STAFF'S
REQUEST ANALYSIS
AND
RECOMMENDATION

05TS0196

Darrel Neilson
(The Battery At Old Gun)

REQUEST: Tentative Subdivision plat approval.

05TS0196-1

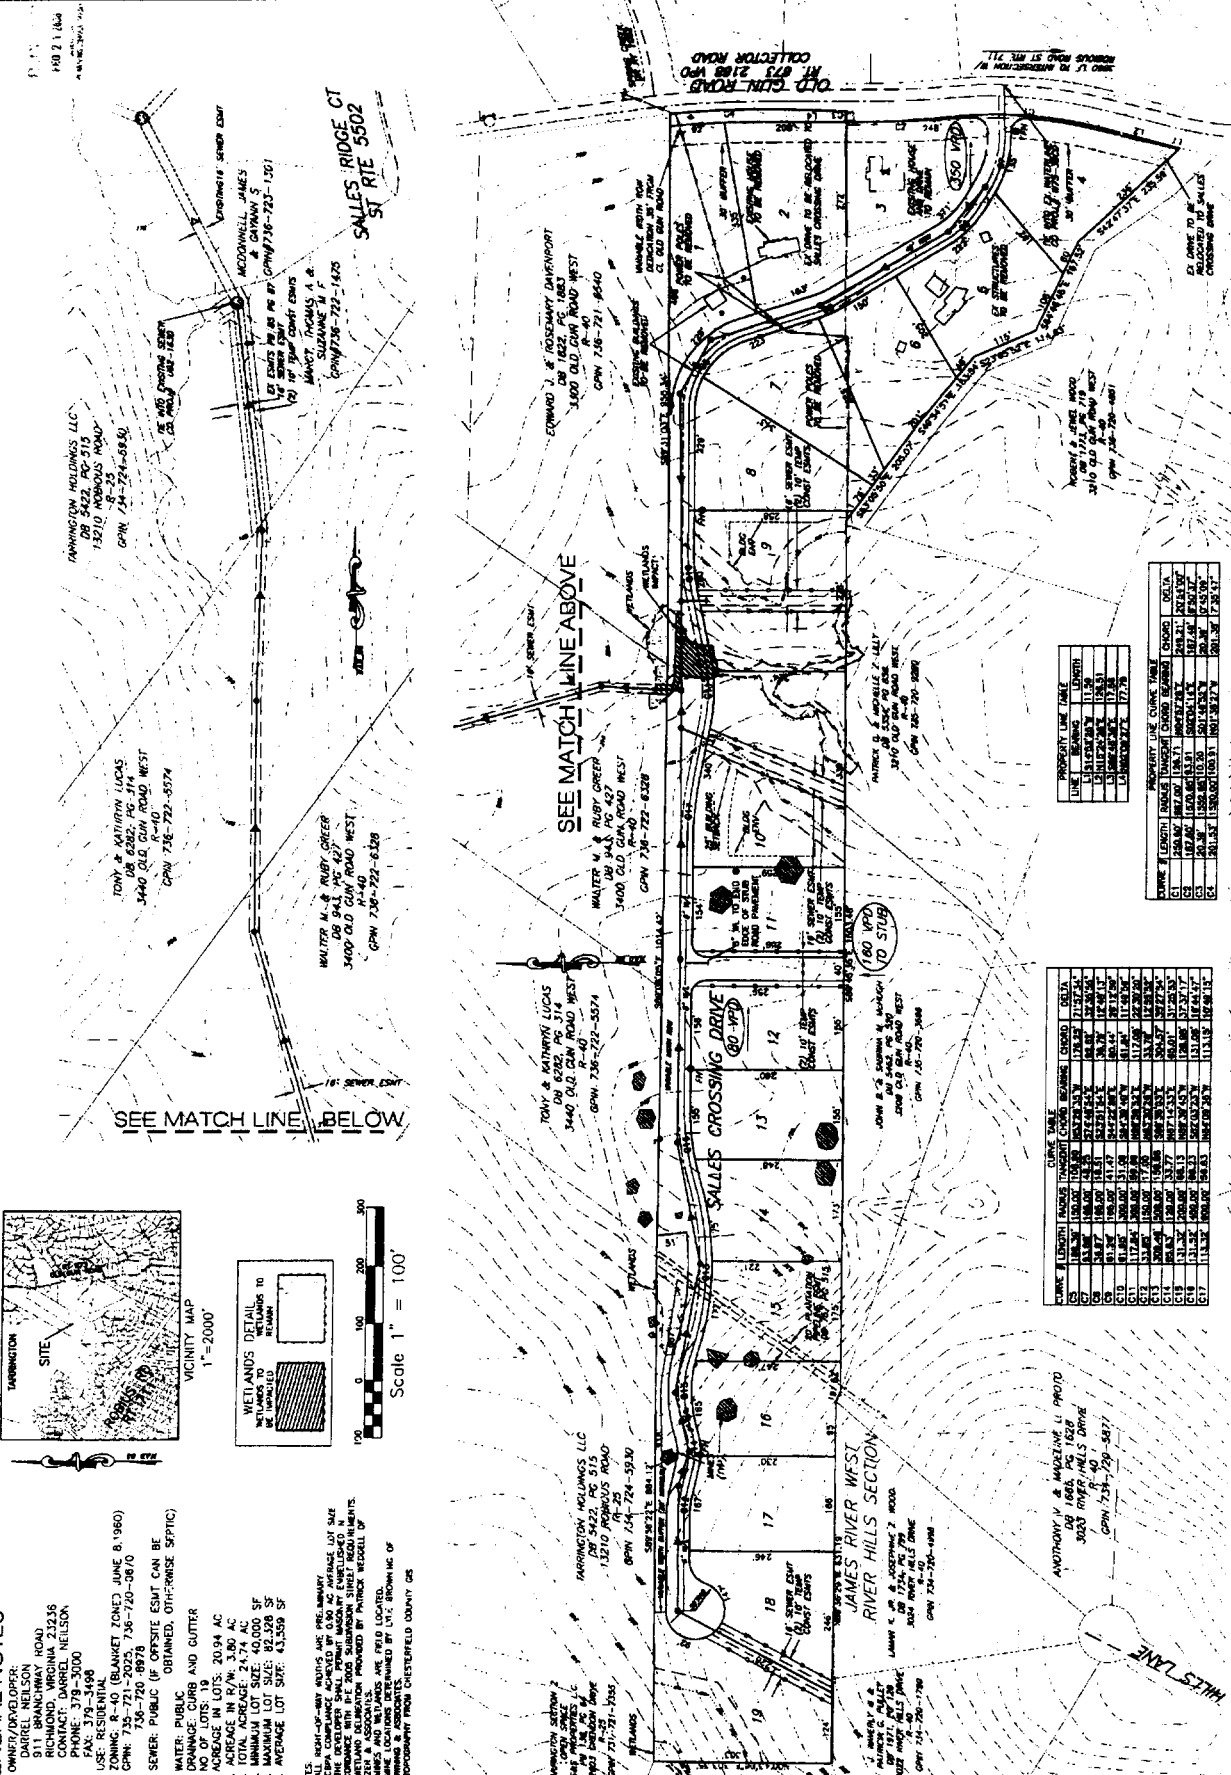
1. Thirty five (35) feet of right of way, measured from the centerline of Old Gun Road, shall be dedicated to and for the benefit of Chesterfield County, free and unrestricted, in conjunction with recordation of the first section of this tentative.
(T)
2. The ditch line on Old Gun Road shall be relocated to provide an adequate shoulder in conjunction with road construction of the first section of this tentative.
(T)

3. The driveway for the existing residence located at 3220 Old Gun Road West and the adjacent residence located at 3230 Old Gun Road West shall be relocated from Old Gun Road to the Salles Crossing Drive as part of construction of Salles Crossing Drive. (T)

4. There shall be no road connection between Salles Crossing Drive and Grayscott Lane in the Tarrington Subdivision and no driveway connection from any lots in the Tarrington Subdivision to Salles Crossing Drive. (T)

5. A stub right of way shall be provided between lots 5 4 and 6 5 to 3210 Old Gun Road West, parcel 736-720-4851. (T)
6. Buffers required to negate double frontage lot conditions shall be recorded as open space. (P)

13. The areas of storm-water runoff concentration as discussed in the Environmental Engineering Department tentative report dated April 18, 2006, will be field located and shown on the plans. The construction plans shall designate the affected lots with an NBP, and an engineered storm sewer, filling, grading, and drainage plan shall be included in the construction plans. (EE)
